Access Compliance Report

Public Rights-of-Way

(Curb Ramps)

Intersection ID: N/A	Main Street: AGNEW_DR	Cross Street: KELBURN_LN	Location: SW
ADA ID: 0CC6096DA145	Ramp Type: BlendTrans1	Initial Pass/Fail: Fail	Overall Compliance: No
Codes/Mitigation Info/Possible Solution			Severity Score: 10
			Field Measurements/Component Compliance

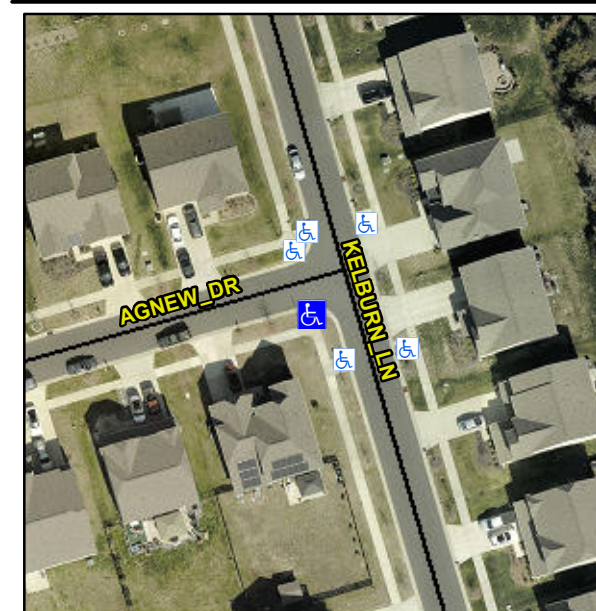
Not Found, R304.5.1, R304.5.3

Compliance	Description	Data	Compliance	Description	Data
N/A	Ramp Length (in)	101.0	Yes	BlendTrans Slope (%)	3.8
No	Ramp Width (in)	46.0	No	BlendTrans XSlope (%)	2.5
N/A	Flare Type LT	N/A	N/A	Flare Type RT	N/A
N/A	Flare Slope LT (%)	N/A	N/A	Flare Slope RT (%)	N/A
N/A	Flare Traversable LT?	N/A	N/A	Flare Traversable RT?	N/A
N/A	Landing Length (in)	N/A	N/A	DWS Provided?	N/A
N/A	Landing Width (in)	N/A	N/A	DWS Contrast?	N/A
N/A	Landing Slope (%)	N/A	N/A	DWS Length (in)	N/A
N/A	Landing X Slope (%)	N/A	N/A	DWS Full Width?	N/A
N/A	Landing Curb? (Y/N)	N/A	N/A	DWS Offset (in)	N/A
N/A	Shared Landing?	N/A			
N/A	Gutter Ponding?	N/A	N/A	Gutter Slope (%)	N/A
N/A	Gutter Lip Ht (in)	N/A	N/A	Gutter X Slope (%)	N/A
N/A	Painted X Walk1?	No	N/A	Painted X Walk2?	N/A
	X Walk 1 Direction	To N		X Walk 2 Direction	N/A
	X Walk 1 Width (in)	N/A		X Walk 2 Width (in)	N/A
	X Walk 1 Slope (%)	3.8		X Walk 2 Slope (%)	N/A
	X Walk 1 X Slope (%)	3.5		X Walk 2 X Slope (%)	N/A

N/A	Ramp inside XWalk1?	N/A	N/A	Ramp inside XWalk2?	N/A
	Road Slope (%)	3.5		Clear Space?	N/A
	Road X Slope (%)	3.8	N/A	Clear Space to XWalk (in)	N/A
N/A	Any Obstructions?	N/A	N/A	Storm Grate/Utility Hazard?	N/A
	Obstruction Type			Storm Grate/Utility Type	
		N/A			N/A
			Yes	Surface Condition? (G/P)	Good
			No	Curb Slope (%)	7.8

Remove & Replace Curb Ramp With Two New Directional Ramps or Equivalent.
